City Unified School District

ADDENDUM NO. 1

Date: February 17, 2017

10GBASE-LRM SFP Module
10 LC to LC 9/125 Singlemode Duplex Yellow 3 Meter Fiber Cable

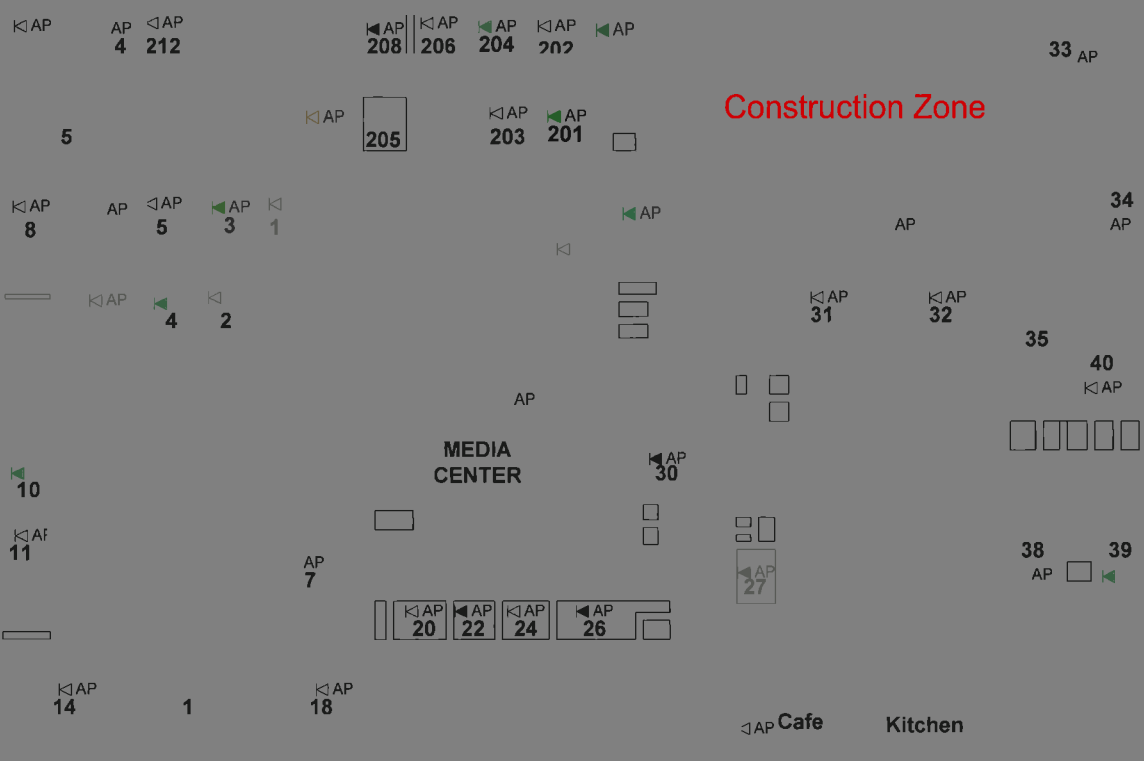
Architect's scope of work does not include existing
map for reference
